**RE: Expedited Settlement Agreement, Number: ES-120112-2  
CDPS Permit No: COR 03D961**

## EXPEDITED SETTLEMENT AGREEMENT

RE:    Facility Inspection/**Compliance Advisory**  
      Metropolitan Club  
      CDPS Permit No. COR-03D961  
      El Paso County

## Stormwater Inspection Report

Photograph 1 – Looking southeast Lots 67-72. Red arrows indicate direction of flow

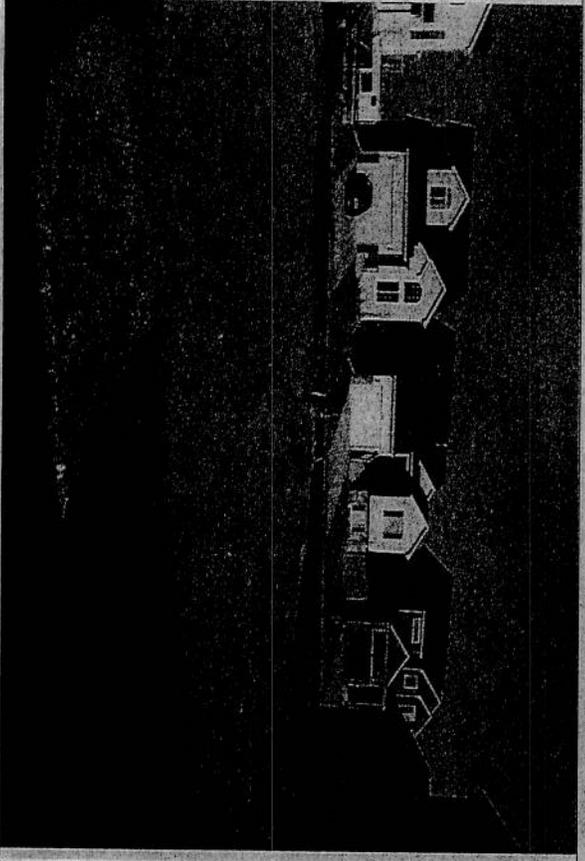
6. It was noted during the inspection that inadequate BMPs were implemented to manage stormwater runoff from the land disturbance and sediment stockpiles located on Lots 67-72 (see photos 1-4). Stormwater runoff from this disturbed area discharges to a down gradient storm sewer inlet located along Shinnecock Court. The storm sewer discharges to Detention Pond 2. A series of curb check rock socks in combination with a plastic pipe wrapped in fabric were placed together in front of the storm sewer inlet to act as an inlet protection device. Inlet protection devices are not designed to function as the sole BMP to remove sediment loading from stormwater runoff coming from the up-gradient disturbed areas. Inlet protection BMPs are intended to be used in conjunction with up gradient BMPs and only as a polishing measure, not as the primary sediment removal device. No other BMPs were implemented up gradient from the inlet protection device for the disturbed area. BMPs to manage the stormwater runoff from the disturbed areas must be

implemented up-gradient of the storm drain inlet to be used in conjunction with the inlet protection device in order for the inlet protection device to function correctly. All BMPs must be implemented according to installation and implementation specifications outlined in the SWMP.

Photograph 5 - Lot 72 concrete/mason waste and mixing sand

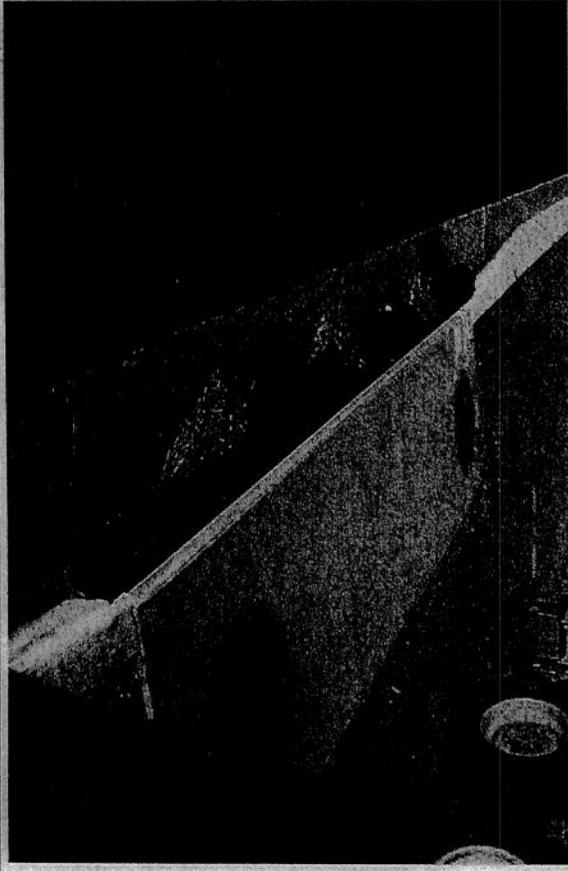
10. It was noted during the inspection that BMPs were not implemented to ensure that concrete/mason washout activities do not result in the contribution of pollutants associated with the washing activity to stormwater runoff. A designated concrete washout area was located on Lot 8. However, the concrete washout area was not being utilized to contain all the concrete/mason washout waste material. Concrete/mason washout waste was discharged to the ground in two locations

on Lot 72 (see photos 5 and 6). BMPs were not implemented at Lot 72 to ensure that the concrete/mason washout waste did not result in the contribution of pollutants associated with the washing activity to stormwater runoff. As a result, there was potential to contribute pollutants from the concrete washout waste to stormwater runoff that discharges to a down gradient storm sewer inlet located along Shinnecock Court. The storm sewer discharges to Detention Pond 2. BMPs must be implemented to ensure that concrete washout activities do not result in the contribution of pollutants associated with the washing activity to stormwater runoff.
